WATER QUALITY
M E M O R A N D U M

Utah Coal Regulatory Program

SUBJECT: First Quarter 2015 Water Monitoring, Andalex Resources, Centennial Mine, C/007/0019, Task ID #4828

Figure 1. Surface to ground water levels, 1989-2015

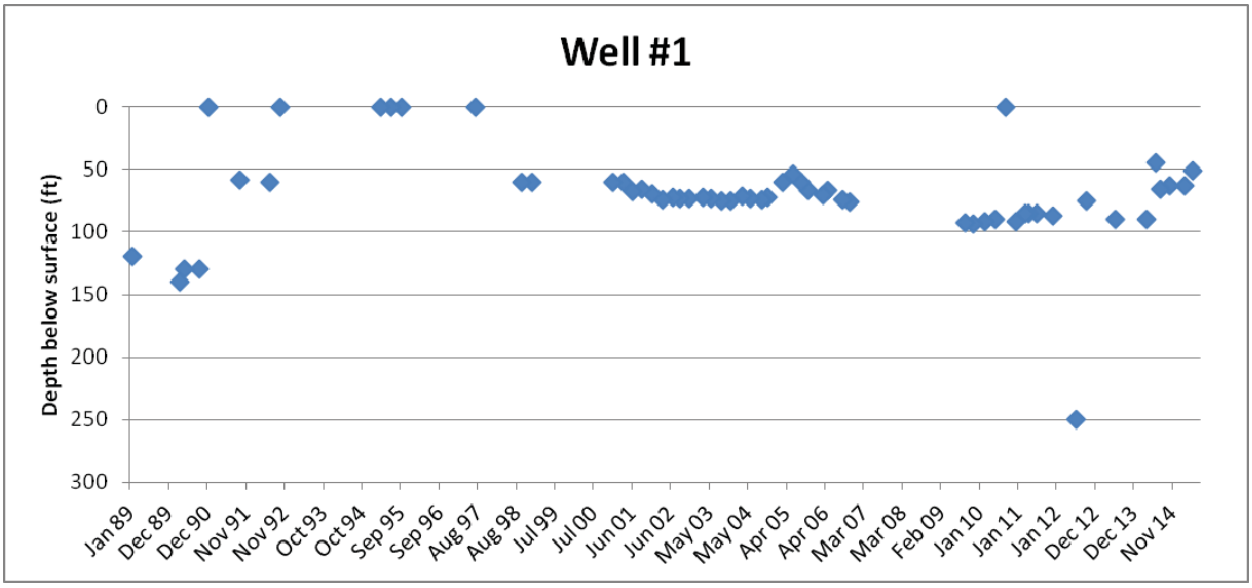
The Q1 2015 depth to water level measured 63 feet, which appears to be consistent with data from previous year's seasonal data.

The continued examination of the depth to water at Well #1 is required.
